**Item 7.****Development Application: Installation of Five New Automatic Public Toilets at Various Locations – D/2021/1088****File No.:** D/2021/1088**Summary****Date of Submission:** 11 October 2021**Applicant:** QMS Media**Architect/Designer:** Grimshaw Architects**Owner:** City of Sydney Council**Planning Consultant:** Mecone**Heritage Consultant:** City Plan Heritage**Cost of Works:** \$2,289,760.00**Zoning:** The sites are located within the B8 Metropolitan Centre, RE1 Recreation and SP2 Infrastructure zones.

**Proposal Summary:** The application seeks consent for five (5) new automated public toilets (APTs) in the Central Sydney area between Alfred Street in the north and Quay Street in the south, as well as in Paddington on William Street. The APTs include green walls, with some also including green roofs. No advertising panels are proposed to be attached to the APTs.

Figure 11: Site plan of A1022

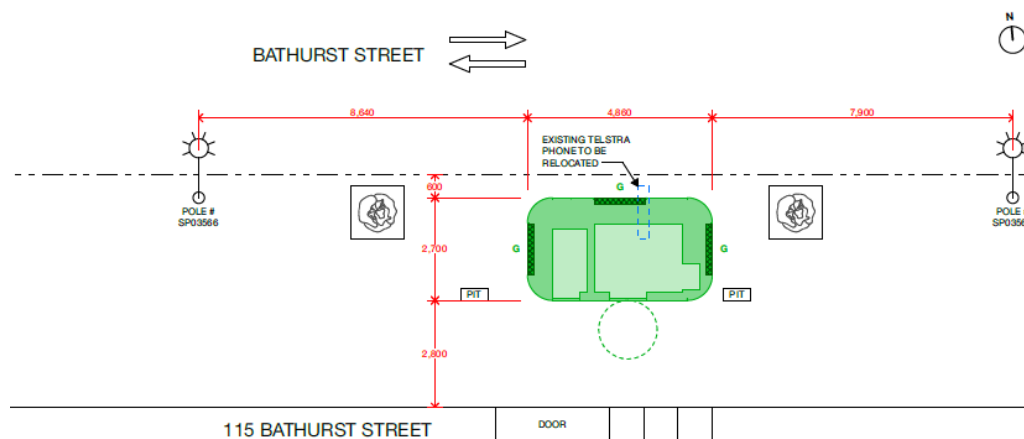
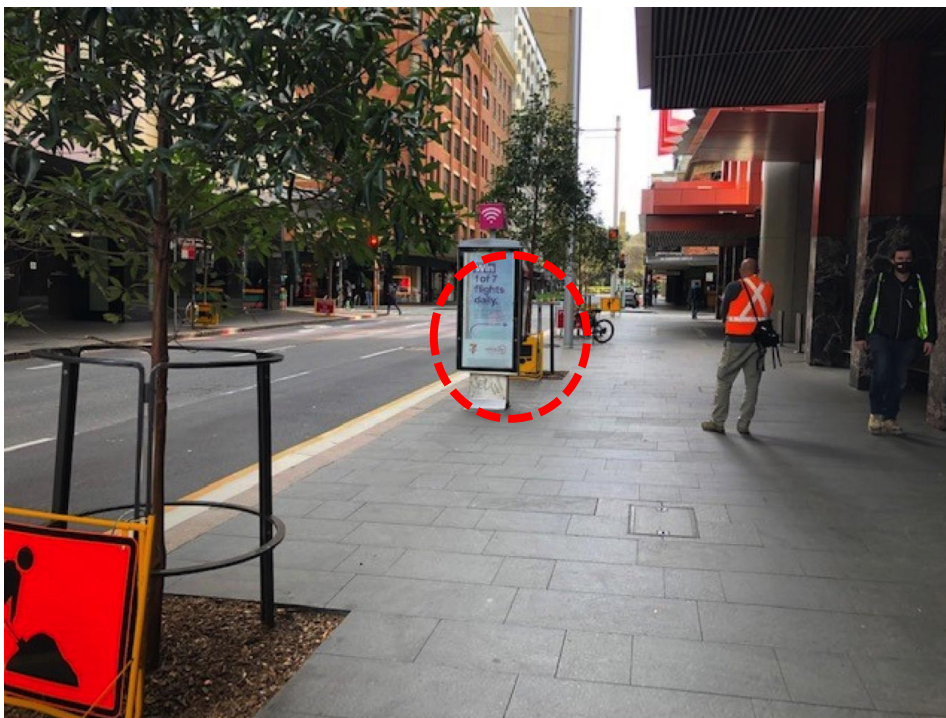
34. The site is located within the SP2 Infrastructure (Classified Road) zone. As identified in the Sydney LEP 2012 compliance table above, APTs are prohibited in the SP2 Infrastructure (Classified Road) zone. The Applicant submits that the proposal is permissible with consent in the zone, in that the proposed APT being ordinarily incidental or ancillary to development for 'infrastructure' with it providing free-to-use,

35. Council's Planning Unit does not support this position. The public toilet serves its own purpose, it is not component of the dominant purpose (as a road) but an independent use in the SP2 classified road zoning. The proposed facility is not considered to be ordinarily incidental or ancillary to the road use, it is not considered to be a minor element and is not required for the road to function properly as may be the case with other ordinarily incidental and ancillary structures such as road signage, traffic lights etc.

36. As the APT is prohibited in the zone, its sought location is not supported.
37. Additionally, during the assessment of the application, Council's Planning Assessment Unit raised concerns regarding the proposed location of A1022 due its proximity to the main lobby of 115 Bathurst Street, and there being insufficient pedestrian walking space on the footpath in this location of high pedestrian volumes.

39. Despite the above, Council staff are of the opinion that A1022 is an inappropriate location for a public toilet. The footpath has a high pedestrian usage with residents and workers entering the mixed-use development and with Bathurst Street being a main east-west thoroughfare for pedestrians in the city. The proposed location will impact on this pedestrian flow. The proposed APT installation will also obstruct ground floor views from the recently constructed development at 115 Bathurst Street, which offers active surveillance to the street.

40. Overall, the proposed new APT in this location is not considered to meet the City's design excellence provisions under Clause 6.21C of the Sydney LEP 2012, which requires that the land is suitable for the proposed development, that pedestrian access and circulation requirements are addressed, and appropriate interfaces at ground level between the building and the public domain are achieved.

38. In response, the applicant submitted that the proposed APT is not located to obscure or interfere with the main entrance of the adjacent mixed-use development and is located where the existing payphone is currently located, as well as that the clearance provided between the APT and the adjacent building is 2.8m which exceeds the minimum distance required in the City of Sydney – Street Furniture Placement and Design Guidelines, March 2021.

41. As such, a condition of consent is recommended in Attachment A to delete this APT from the approval.

Figure 14: Site plan of A1026

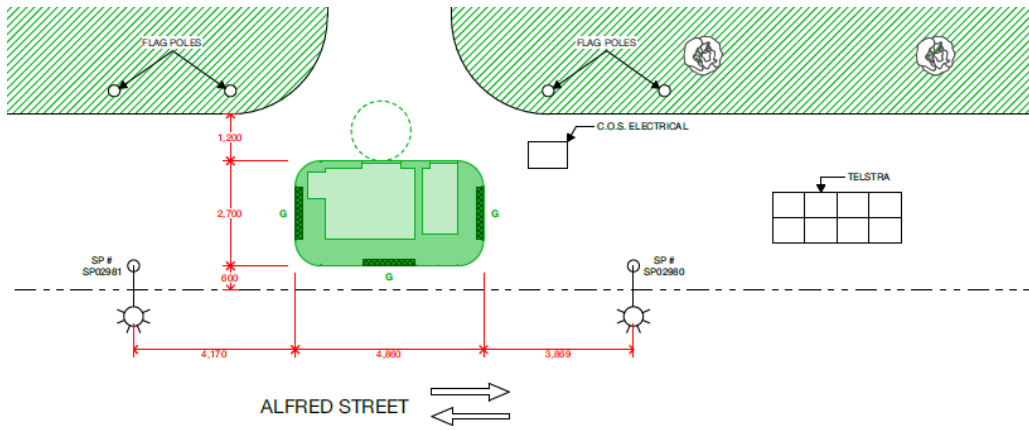
43. During the assessment of the application, TfNSW raised the following concerns regarding A1026:
- It reduces the effective footpath width to 1200mm and as a result reduces the capacity of the footpath and may impact the flow of pedestrians.

- It is located 600mm away from the street kerb, however the distance between the APT and a light rail vehicle on Alfred Street is unclear.
  - It is not supported as the light rail drivers' line of sight to pedestrian movements would be obscured in the vicinity of this site and this would likely increase pedestrian related incidents at this location.

- It was requested that the APT be relocated in consultation with TfNSW and the Sydney Light Rail Operator to provide clear light rail drivers' line of sight to pedestrian movements.

45. Following the applicant's response, TfNSW provided comments on 18 March 2022. TfNSW advised that although the APT at this location is setback 1.5 metres from the Light Rail dynamic kinetic envelope, which aligns the smart pole locations, the agency believes that the APT will block the line of sight between the Light Rail operator's vision and pedestrians significantly more than a smart pole.
46. As such, TfNSW reiterated that consideration is to be given to relocate the APT in consultation with TfNSW and the Light Rail operator to ensure a clear line of sight in a highly pedestrianised environment.
47. A condition of consent is recommended in Attachment A so that A1026 is not approved at this stage, and that any consideration of an APT in this location involves further consultation with TfNSW.

- The 1200mm footpath width between the APT and adjacent verge complies with the minimum 1.2m setback specified at page 18 of the adopted City of Sydney – Street Furniture Placement and Design Guidelines, March 2021.

- Through engagement with TfNSW, the smart poles near the APT are set back 1.5 metres off the Dynamic Kinematic Envelope (DKE) line, which is the outline of the space occupied by a light rail vehicle when in motion. The APT aligns with this setback as a clear delineation between the footpath and light rail line environment. The gutter is a clear signal to pedestrians that they are stepping off the footpath and into a road / light rail environment.

- As stated above, a condition of consent is recommended so that this APT is not approved as part of this application, and that any consideration of a public toilet in this location involves this consultation process. Other conditions of consent recommended by TfNSW are also included in the conditions of consent included at Attachment A.
